## Major Design Improvement: 2005-2000 Ford Super Duty Truck & SUV Front Stabilizer Bar Links

Brand	Supreme	Product	Stabilizer Bar Link	Date	July 2021
<b>Part Number(s)</b>	MS40805/MS40806

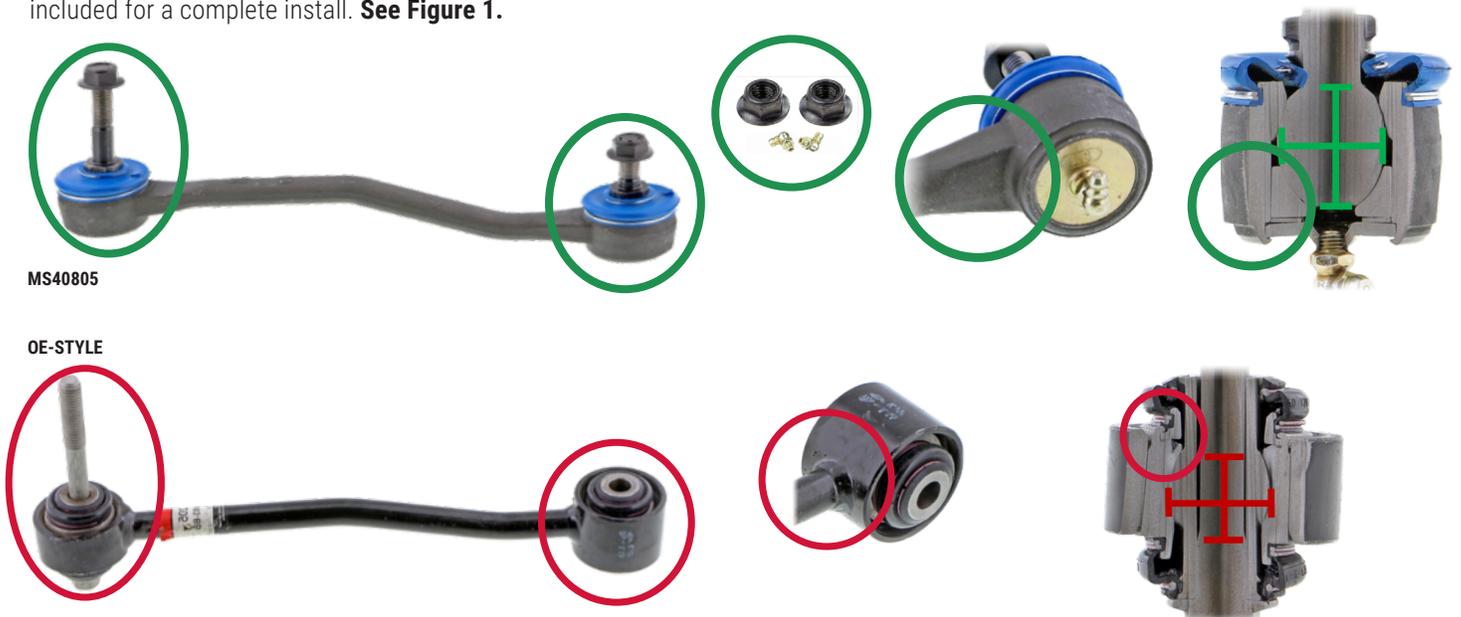
The OEM (PNs: 1C3Z5K483BB/1C3Z5K483BA/MEF205/MEF206) and other OE-style front stabilizer bar links for the applications below utilize a non-greaseable plastic bearing and a 3-piece design, wherein the bushing housings are welded to the shaft rod.

Mevotech Supreme front stabilizer bar links MS40805 and MS40806 are engineered with an improved solid steel 1-piece forging. This adds rigidity and strength to the assembly and reduces flex and cycling while the vehicle is in motion. The bushings have been converted to a ball and socket design, which is characterized by greaseable, self-lubricating lower sintered metal bearings for extended part service life and increased heat resistance. Additionally, an increased ball pin diameter optimizes pressure distribution. New hardware is included for a complete install. **See Figure 1.**
